Access Compliance Report

Public Rights-of-Way

(Curb Ramps)

Intersection ID: N/A	Main Street: HOOVER_CREEK_BV	Cross Street: WALKER_BRANCH_DR	Location: S
ADA ID: 9B624649B347	Ramp Type: PerpDiag	Initial Pass/Fail: Fail	Overall Compliance: No
Severity Score: 12.5			
Codes/Mitigation Info/Possible Solution		Field Measurements/Component Compliance

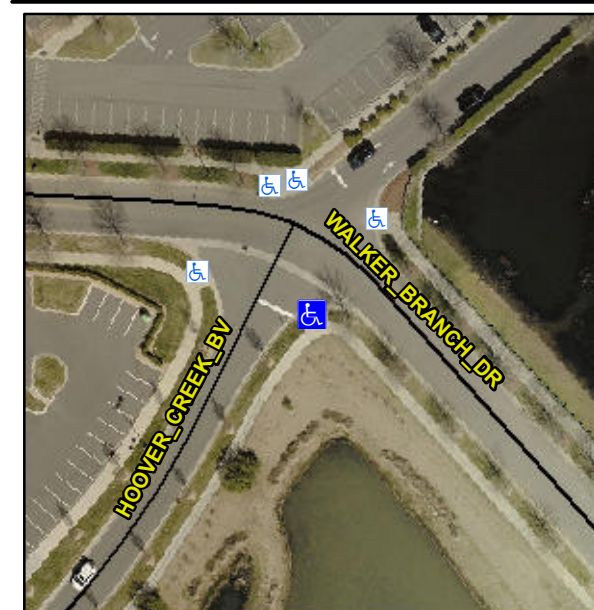
Not Found, R304.5.3

Compliance	Description	Data	Compliance	Description	Data
N/A	Ramp Length (in)	81.0	Yes	Ramp Slope (%)	6.1
Yes	Ramp Width (in)	48.0	No	Ramp XSlope (%)	5.4
N/A	Flare Type LT	N/A	N/A	Flare Type RT	N/A
N/A	Flare Slope LT (%)	N/A	N/A	Flare Slope RT (%)	N/A
N/A	Flare Traversable LT?	N/A	N/A	Flare Traversable RT?	N/A
N/A	Landing Length (in)	N/A	N/A	DWS Provided?	N/A
N/A	Landing Width (in)	N/A	N/A	DWS Contrast?	N/A
N/A	Landing Slope (%)	N/A	N/A	DWS Length (in)	N/A
N/A	Landing X Slope (%)	N/A	N/A	DWS Full Width?	N/A
N/A	Landing Curb? (Y/N)	N/A	N/A	DWS Offset (in)	N/A
N/A	Shared Landing?	N/A			
N/A	Gutter Ponding?	N/A	N/A	Gutter Slope (%)	N/A
N/A	Gutter Lip Ht (in)	N/A	N/A	Gutter X Slope (%)	N/A
N/A	Painted X Walk1?	No	N/A	Painted X Walk2?	No
	X Walk 1 Direction	To NE		X Walk 2 Direction	To NW
N/A	X Walk 1 Width (in)	N/A	N/A	X Walk 2 Width (in)	N/A
	X Walk 1 Slope (%)	5.9		X Walk 2 Slope (%)	1.6
	X Walk 1 X Slope (%)	0.1		X Walk 2 X Slope (%)	4.5

N/A	Ramp inside XWalk1?	N/A	N/A	Ramp inside XWalk2?	N/A
	Road Slope (%)	3.0	N/A	Clear Space?	N/A
	Road X Slope (%)	5.4	N/A	Clear Space to XWalk (in)	N/A
N/A	Any Obstructions?	N/A	N/A	Storm Grate/Utility Hazard?	N/A
	Obstruction Type			Storm Grate/Utility Type	
		N/A			N/A
		Yes		Surface Condition? (G/P)	Good

Remove & Replace Curb Ramp With Two New Directional Ramps or Equivalent.
